February 8, 2024

### ADDENDUM NO. 3

PROJECT: New Offices for Morrow County Health District  
480 Douglas St.  
Mt. Gilead, OH 43338

**08 PURLIN REINFORCING RFI #3**

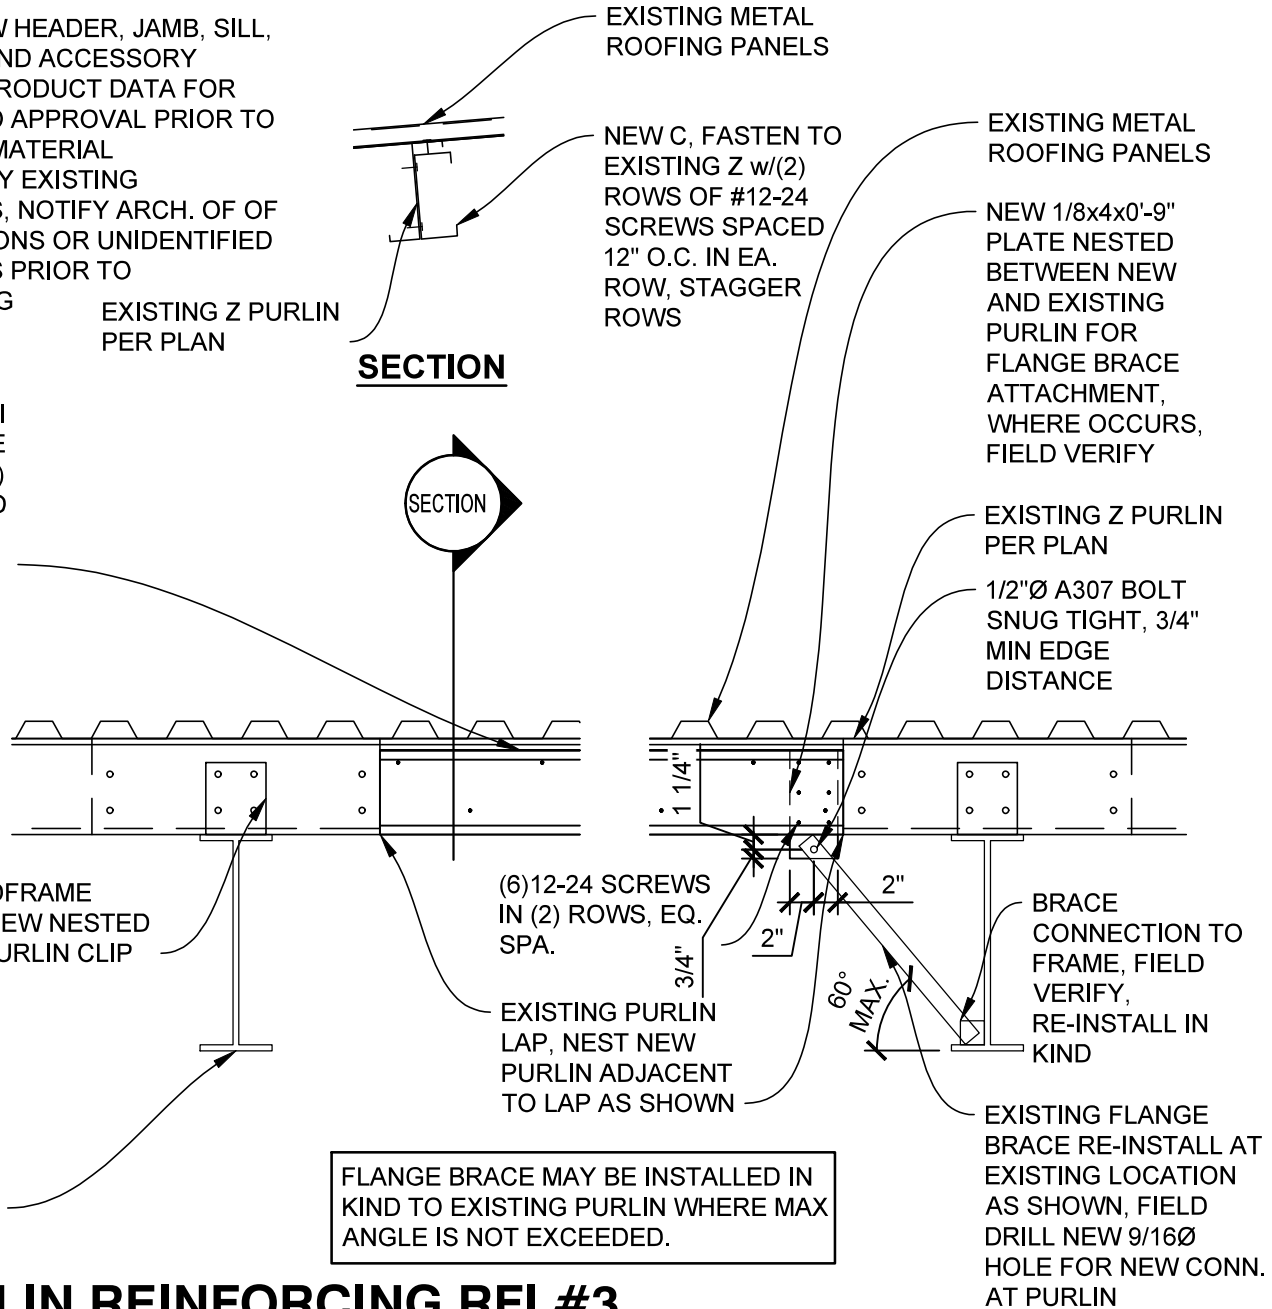
**ITEM #2: Purlin Reinforcing Detail:** See attachment.

- SUBMIT NEW HEADER, JAMB, SILL, ETC., CLIP AND ACCESSORY MATERIAL/PRODUCT DATA FOR REVIEW AND APPROVAL PRIOR TO ORDERING MATERIAL
- FIELD VERIFY EXISTING CONDITIONS, NOTIFY ARCH. OF OF OBSTRUCTIONS OR UNIDENTIFIED CONDITIONS PRIOR TO PROCEEDING

NEW 55KSI  
7x3x12GA. C (MBCI  
STRUCTURAL CEE  
BASIS OF DESIGN)  
CHANNEL NESTED  
IN EXISTING  
PURLIN

AT ENDFRAME  
BUTT NEW NESTED  
C TO PURLIN CLIP
